Product Change Notification

PCN Number: 1008-00

Title: Heatsink GE Infusion Wire Routing Modification

Figure 1. Image of the Twist Module Cooler 43W Heatsink showing the new wire routing slot in the face of the Heatsink.

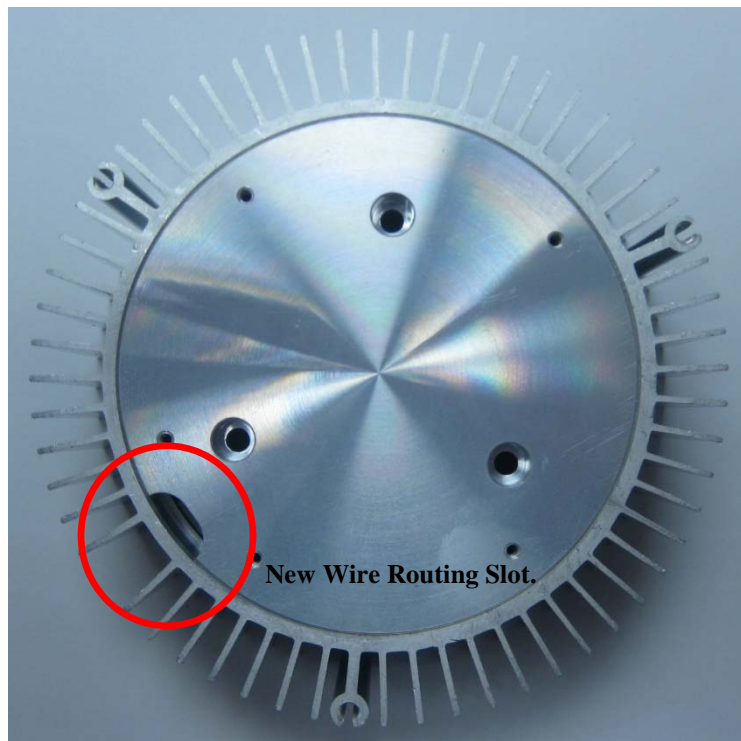
A wire routing slot has been added to the Twist Module Cooler 43W Heatsink. This Heatsink is the primary Heatsink for the GE Infusion Module. The new slot allows the wires of the GE Infusion Module to be routed through the face of the Heatsink.

The part numbers in the table below have been modified to include this new wire routing slot. All future production of these two part numbers will have this change incorporated. This revision is being implemented as a running change. All existing inventory will be used.
